Non-Conformance Report

Project	DTNE
NCR No.	DTNE-NCR-015
NC Date	2020-08-31
Critical Item	<input type="checkbox"/> Yes <input checked="" type="checkbox"/> No

Title	DTNPL FM EMC Test Result Issue				
NC Item	Item Name(Part Name)	DWG No.	Rev	Serial No.	Quantity
	KPLO-DTNPL-SCH	3.0	1012-KB-001F	1	
	Next Higher Assembly	Procedure No.	Rev	Supplier of NC item	
	SBC PBA				
	Subsystem	NC observed location(Org.)		Model	
	DTNPL	KBIO EMC 시험장		<input type="checkbox"/> EM <input type="checkbox"/> EQM <input type="checkbox"/> QM <input type="checkbox"/> PFM <input checked="" type="checkbox"/> FM

DTNPL FM EMC Test (2020.08.05 ~ 2020.08.07, 2020.08.21) 시험 중 Requirement 미충족 사항 발생

■ CM

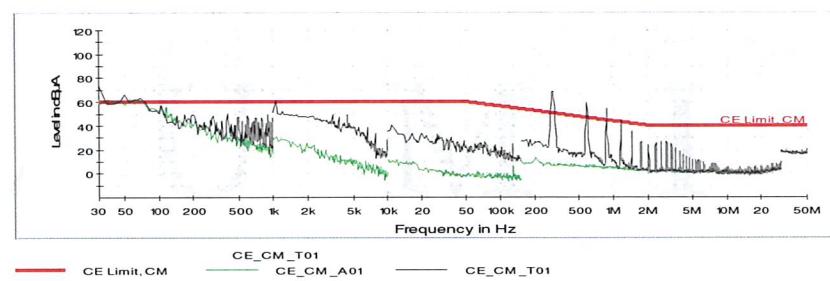
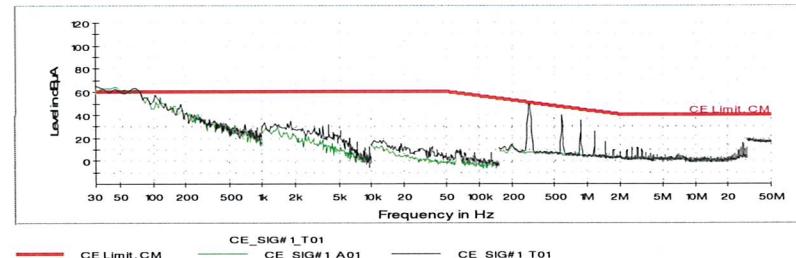
Power line - DM (Return)	Refer EMC specification	뒷장 참조	PASS
Conducted Emission, Frequency Domain, Signal Lines, 10kHz ~ 50MHz	Power line - CM	Refer EMC specification	뒷장 참조	FAIL
	CON_COMM	Refer EMC specification	뒷장 참조	PASS
	-X axis	Refer EMC specification	뒷장 참조	PASS
Radiated Emission, magnetic field, 30Hz ~ 100kHz	+X axis	Refer EMC specification	뒷장 참조	PASS
	Y axis	Refer EMC specification	뒷장 참조	PASS
	Z axis	Refer EMC specification	뒷장 참조	PASS
Radiated Emission, Electric field, 10kHz ~ 18GHz	(10kHz ~ 30MHz) Vertical Polarity	Refer EMC specification	뒷장 참조	FAIL
	(10kHz ~ 30MHz) Horizontal Polarity	NA	NA	NA
	(30MHz ~ 200MHz) Vertical Polarity	Refer EMC specification	뒷장 참조	FAIL
	(30MHz ~ 200MHz) Horizontal Polarity	Refer EMC specification	뒷장 참조	PASS
	(200MHz ~ 1GHz) Vertical Polarity	Refer EMC specification	뒷장 참조	FAIL
	(200MHz ~ 1GHz) Horizontal Polarity	Refer EMC specification	뒷장 참조	PASS
	(1GHz ~ 18GHz) Vertical Polarity	Refer EMC specification	뒷장 참조	FAIL

- (2020.08.27) 해당 부분은 QM 대비 FM에서 GND 연결 구조가 변경된 것으로 판단 되어 ETRI에게 결과를 송부 함
- (20.08.30) ETRI 사에서 KARI에 해당 Issue를 공유, KARI에서 과도한 노이즈 크기가 아닌 것으로 판단이 되어진다는 의견 수령 함

- DTNPL FM 추가 EMC 시험, 보드 수정 없이 KARI에 Waiver 진행 함
